Planning Commission Meeting Agenda Hartland Township Hall Thursday, April 24, 2025 7:00 PM

Hartland Township Planning Commission Meeting Agenda Memorandum

Redwood Living Planned Development (PD) Phase II –Final Plan

Site Plan with Special Land Use Application #22-015
Mini Warehouse Establishment with Outdoor Storage
Old US-23 – Section 28 of Hartland Township (Tax Parcel ID #4708-28-300-023)

C000

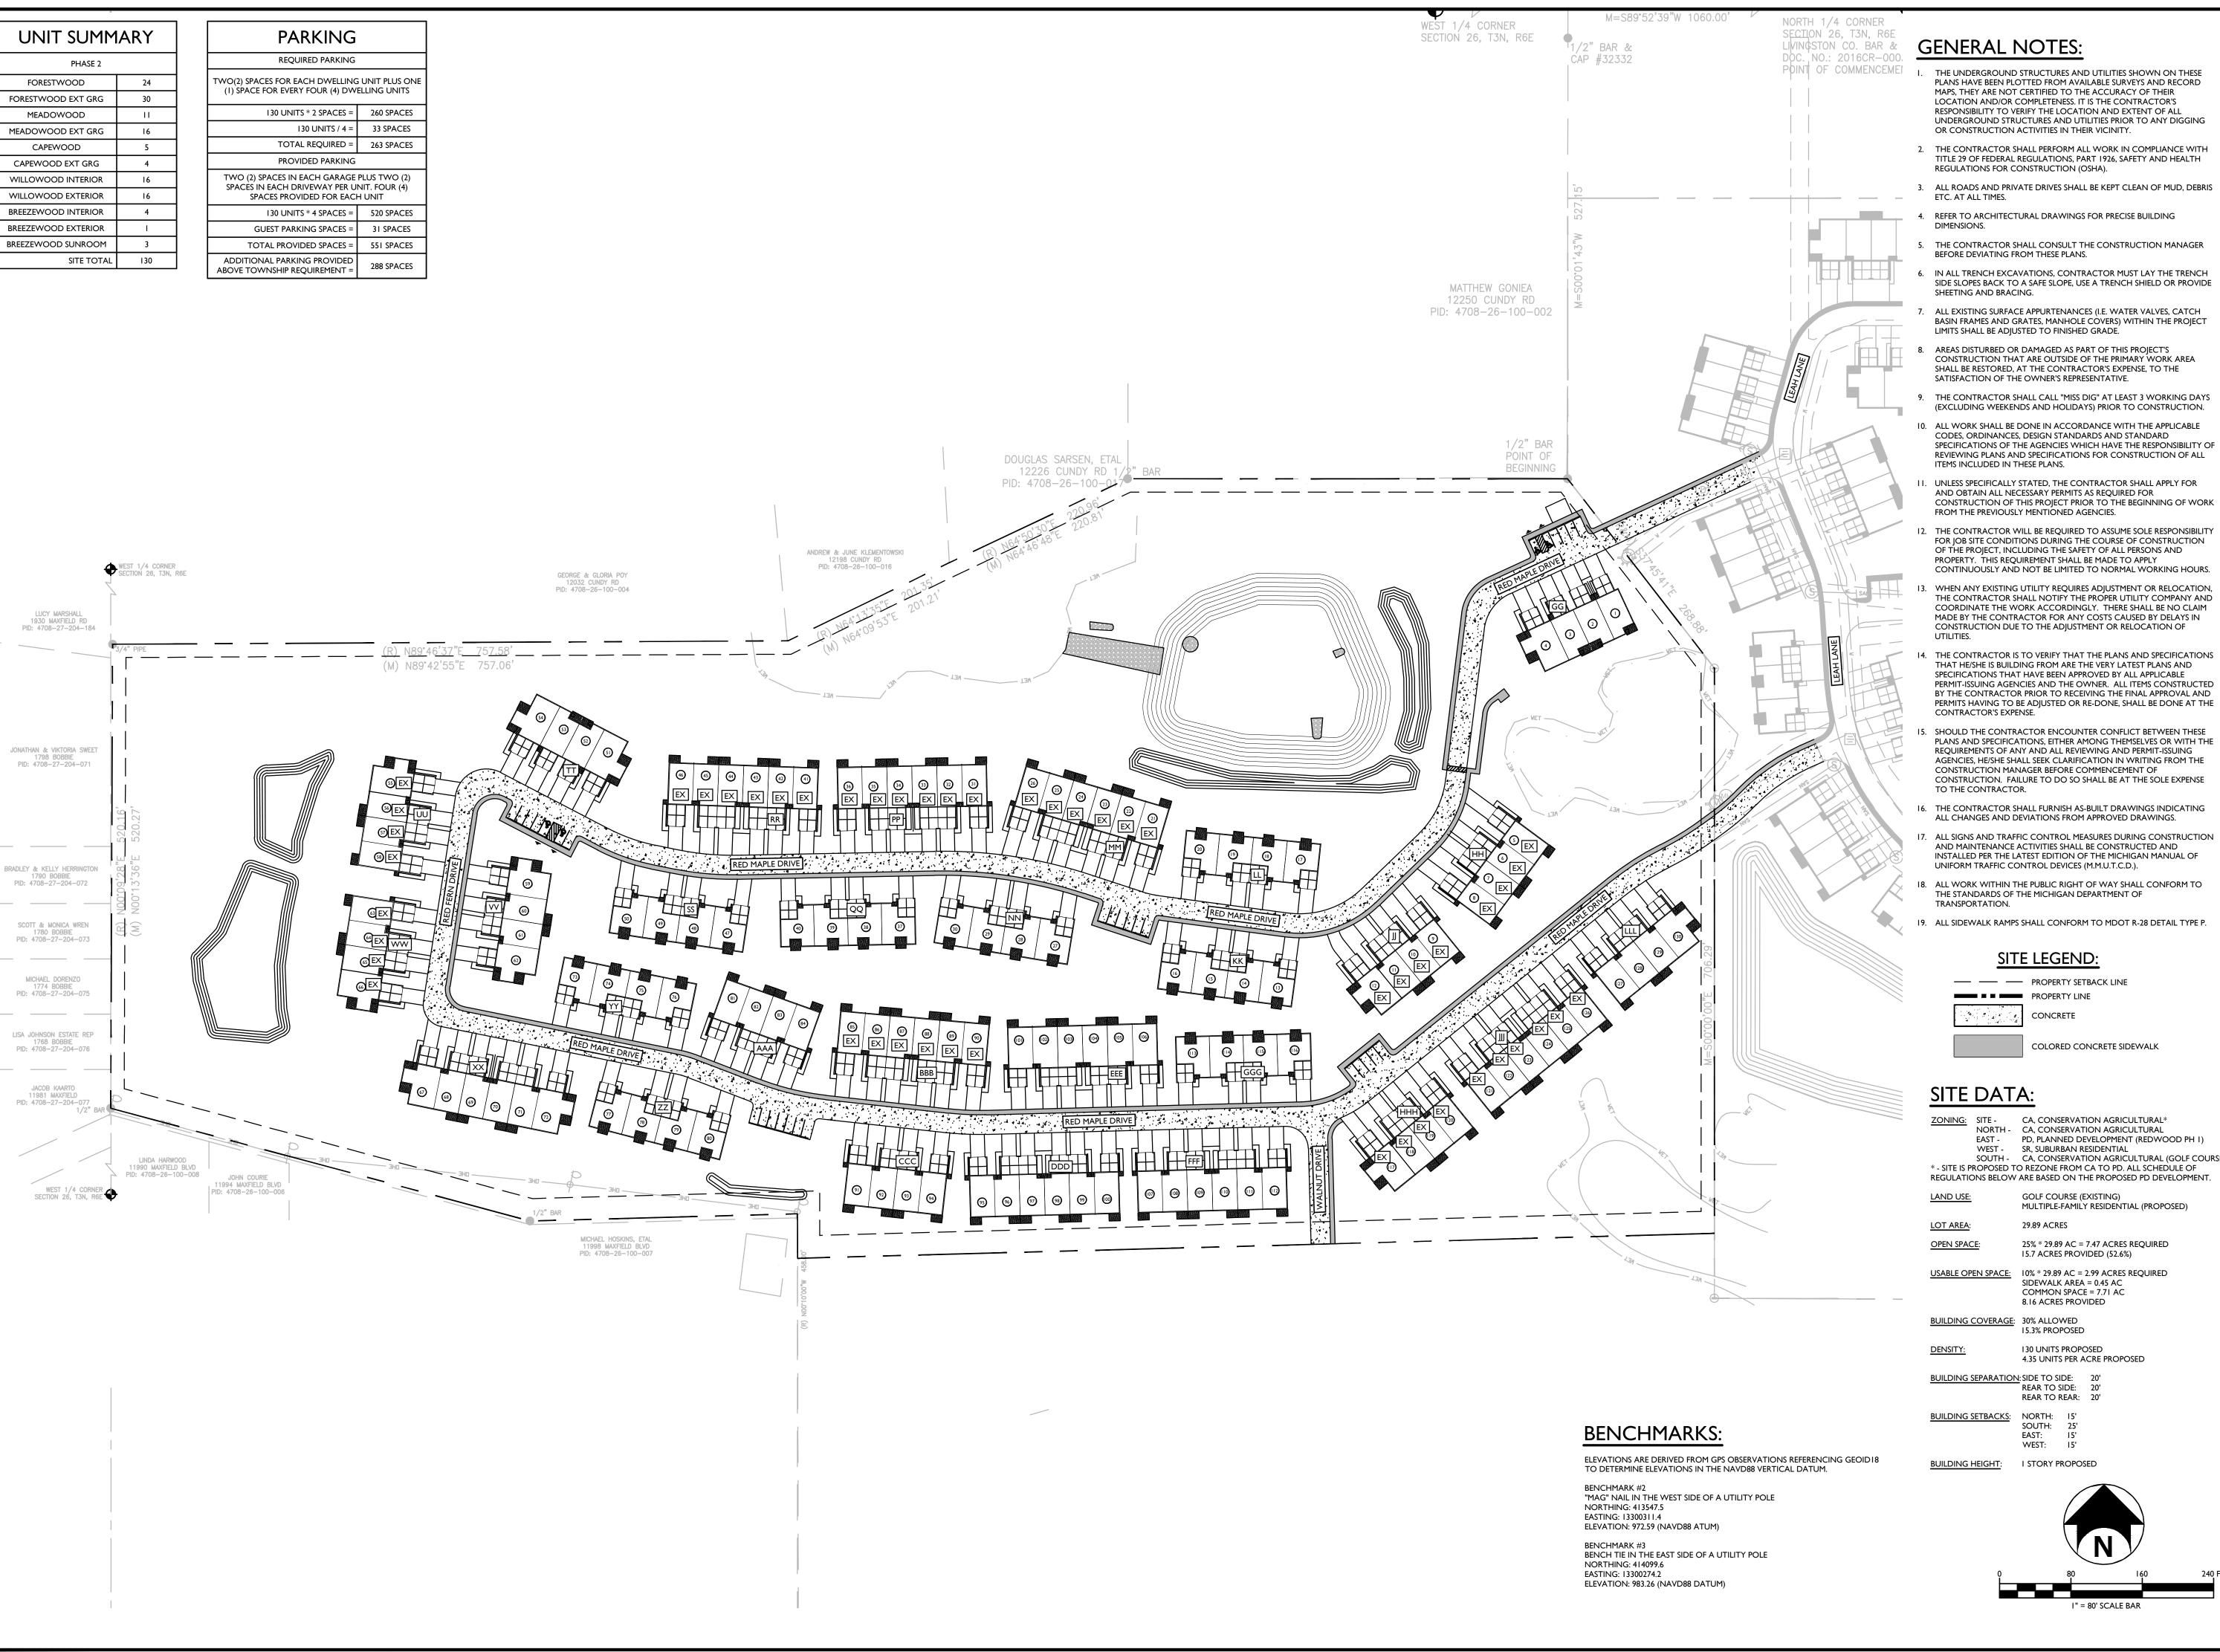
- 1. Provide a copy of Lot Split when completed and include Parcel ID with description on drawing X100.
- 2. Add Soil Erosion and Sedimentation Control sheets to the plan set.
